ADDENDUM NO. 2

May 31, 2013

Duluth International Airport
New Parking Structure and Exterior Wayfinding Signage
Bid Package 2D
Duluth, MN 55811

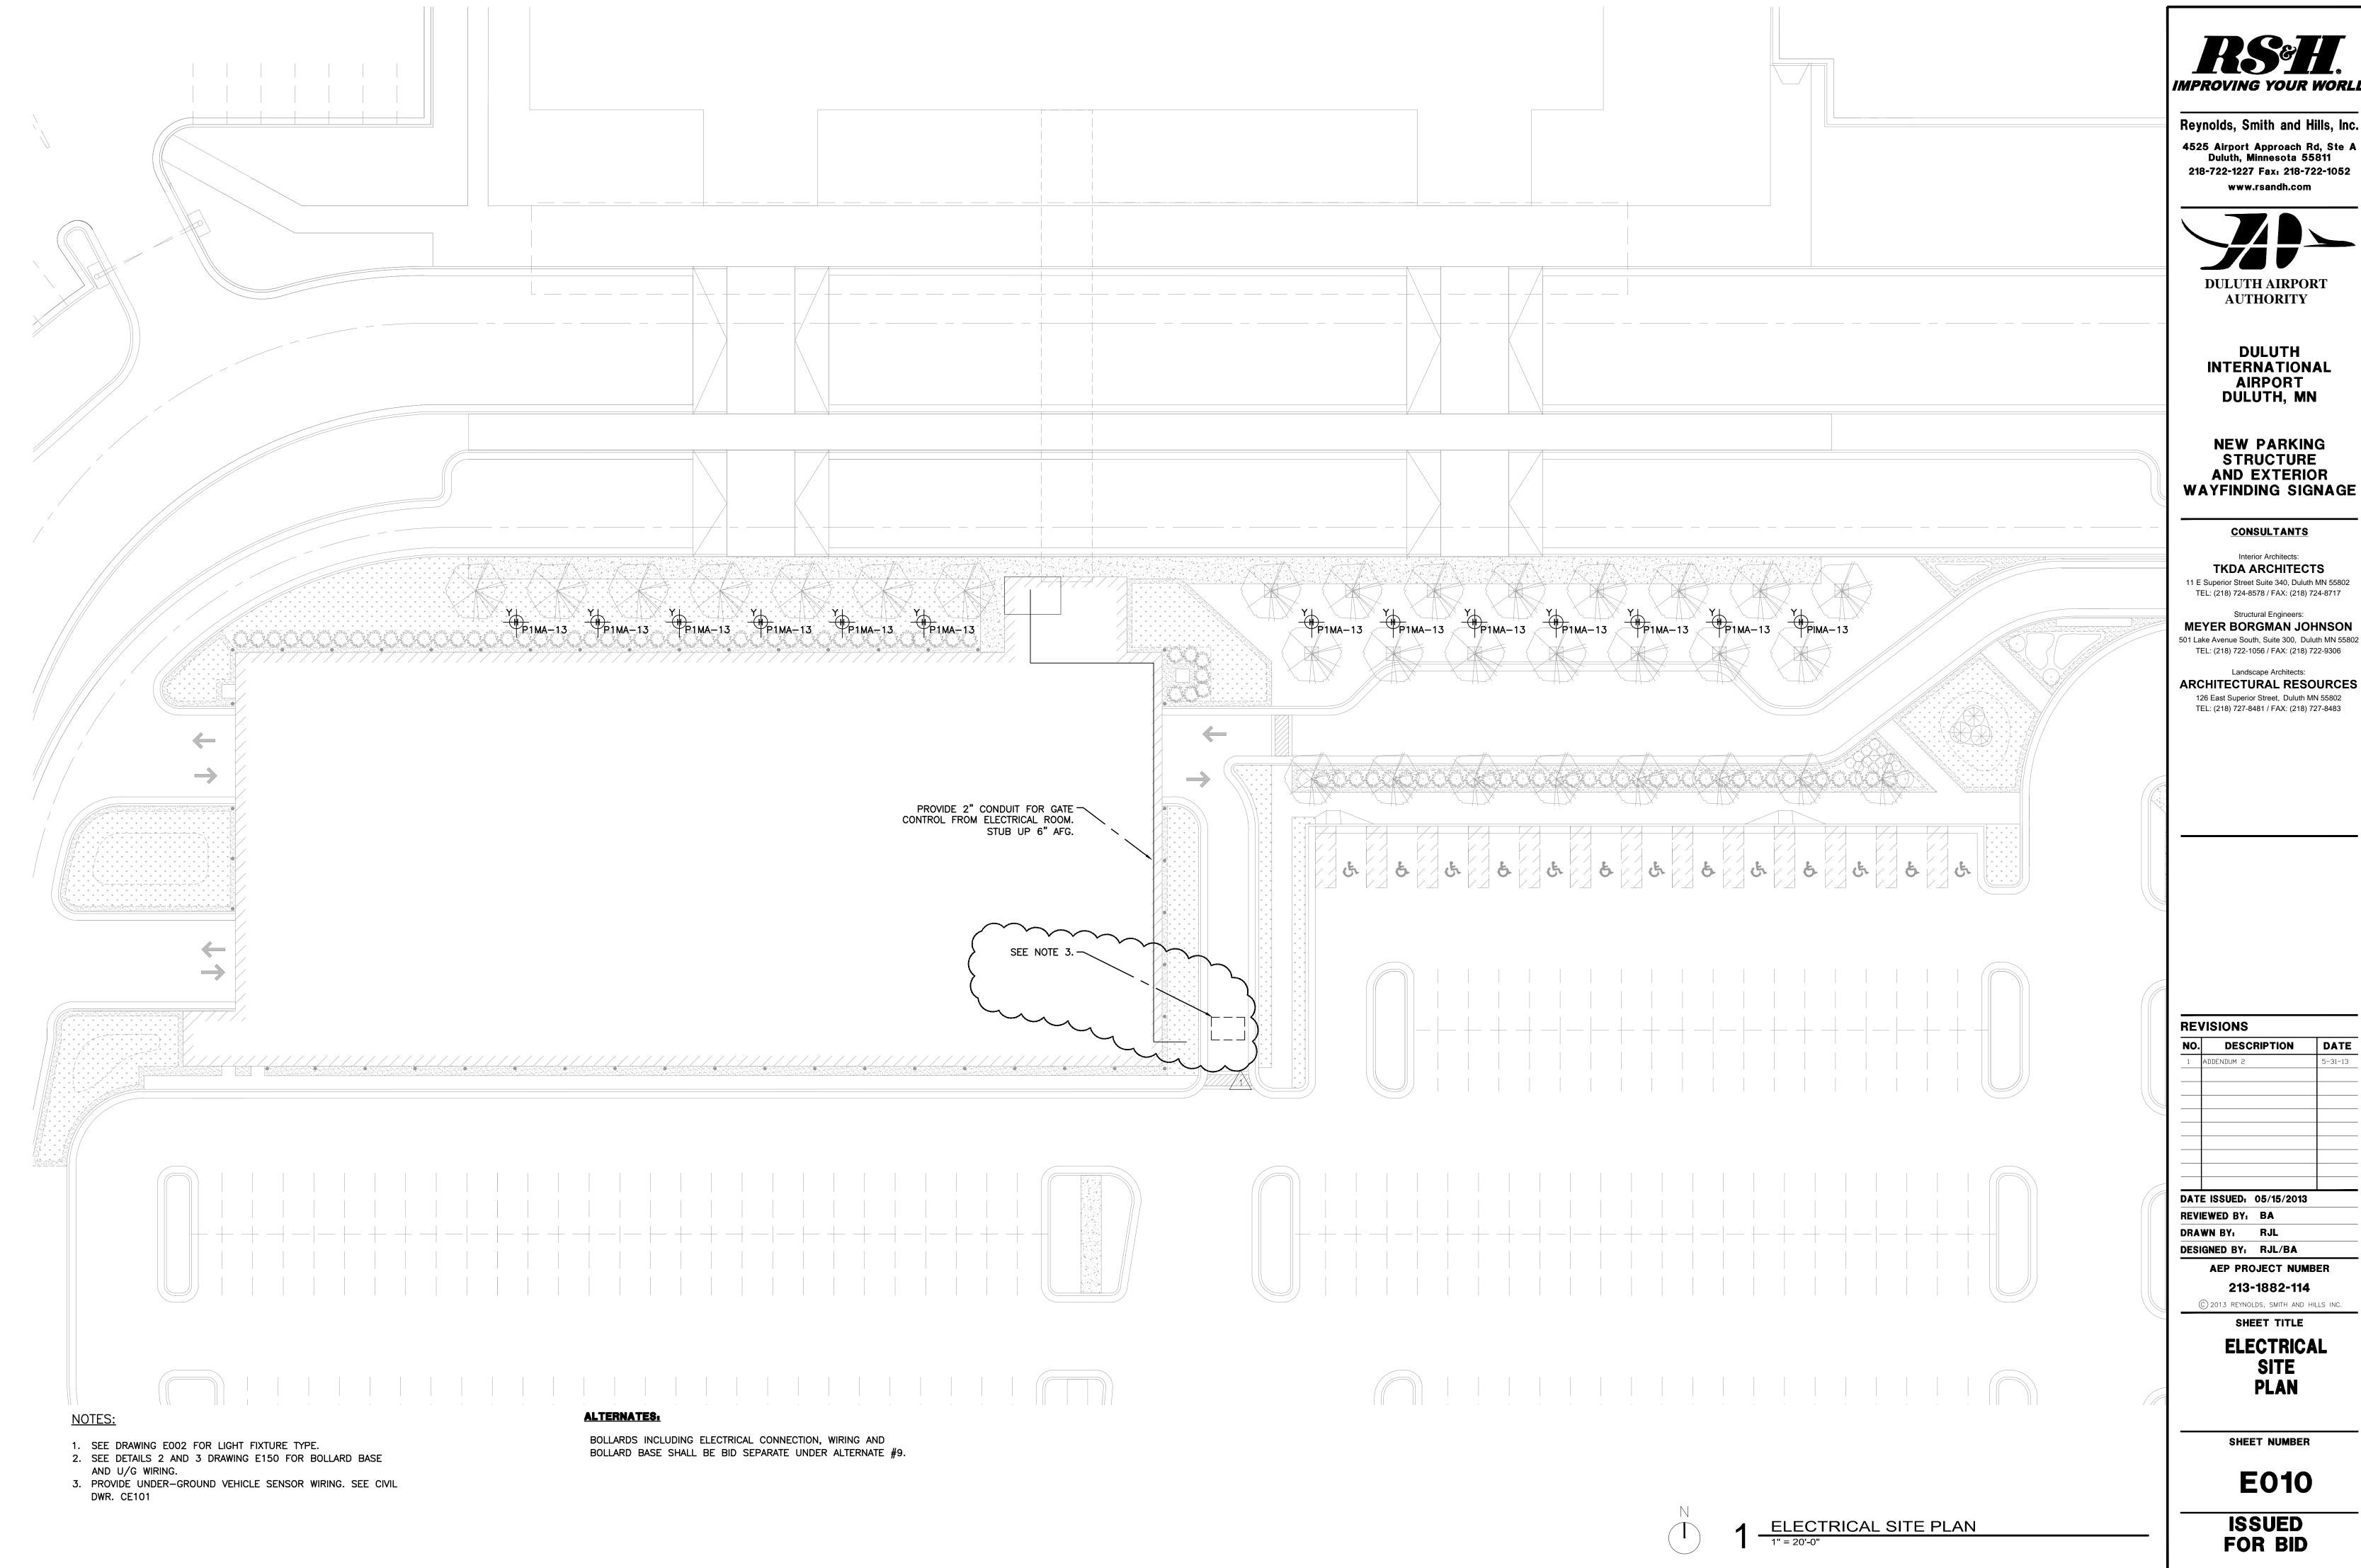
- Add the following to Par. 1.03, M. Coordination of Openings
 Required by Others, Item 2 to read: "Include required sleeves in Precast Floor Plank as shown on Sheet E101 for electrical conduit."

E101 First Level Electrical Plan

Drawing: T:\P\2131882.114 Duluth Parking Structure\CAD\E\E104 Enlarged Skywalk Plan.dwg Plotted on: 5/31/2013 9:35 AM Plotted by: Llazari, Rional

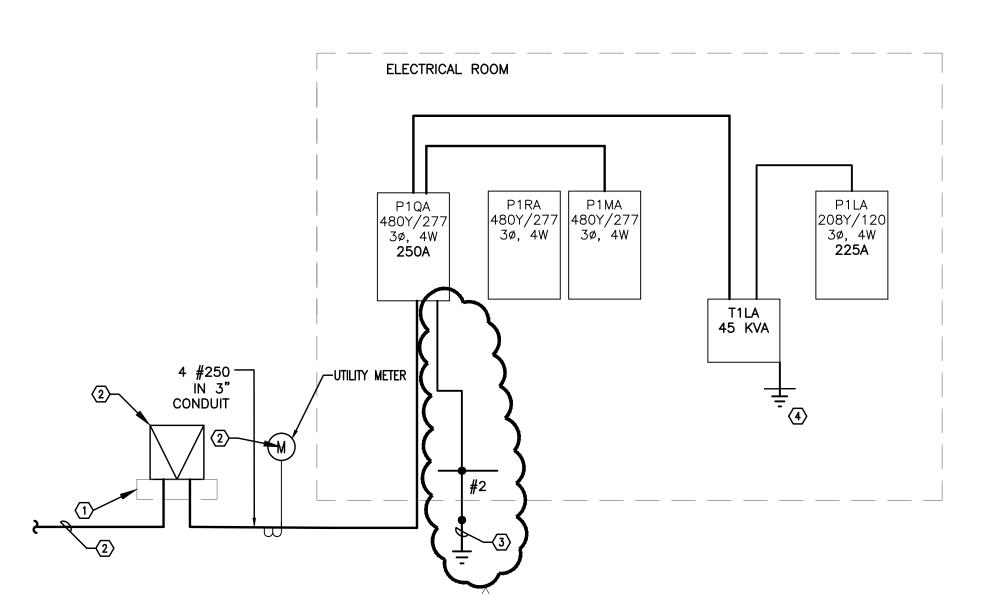
E104 Skywalk Electrical Plan
